# HAN1100 Ultimate Addendum

It has come to our attention that two measurements listed in the Ultimate manual are incorrect. This addendum corrects this issue by providing the correct measurements for the axle location on the wheel pant and the centerline on the firewall.

## Page 56, Step 2

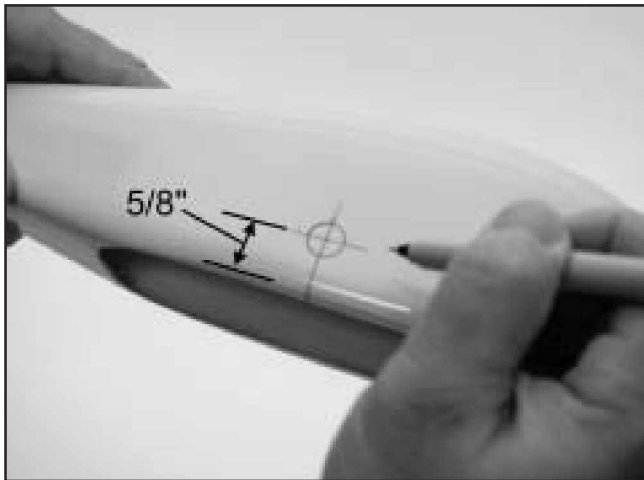
The photo for drawing the centerline on the firewall has the measurement referenced from the wrong side of the engine box. The correct wording and photo are as follows:

Draw a vertical and horizontal centerline on the firewall. The horizontal line is located  $2\frac{1}{2}$ " from the top of the firewall, and the vertical line  $3\frac{13}{16}$ " from the left side of the firewall, as viewed from the front.
